211 HILLSBOROUGH ST.

Chapel Hill, NC

Certificate of Appropriateness - Amendment 03.03.2023

NARRATIVE OF PROPOSALS

ENLARGED SITE PLAN

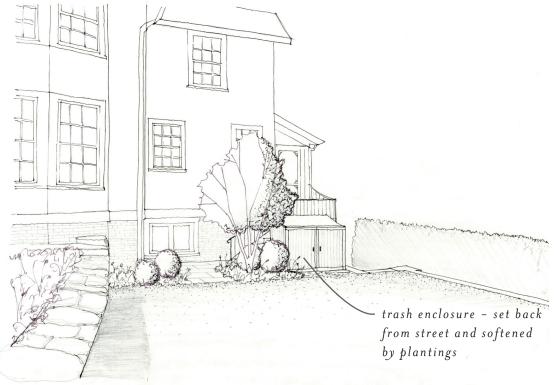
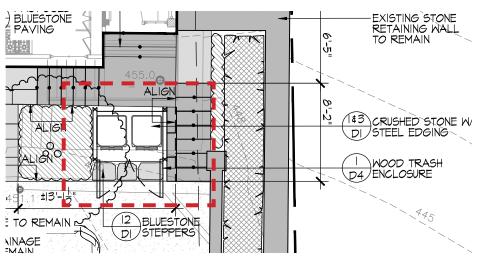
- Landscape architect requests to change the two retaining walls along the north & west setback lines from stone veneer (approved) to stucco. The proposed change to a stucco finish would match the existing stucco finish on the house and would help unify the landscape features to the house.
- Landscape architect requests the Board's consideration & approval for a trash enclosure. The proposed enclosure would provide an area for the owner to store garbage containers. The enclosure would be wooden and tucked into the landscape. The location would provide ease of access getting the containers in and out on collection days.
- Landscape architect requests the Board's consideration & approval for the pedestrian gates at the stone walk and public sidewalk. The proposed gates would provide a sense of privacy to the owner.
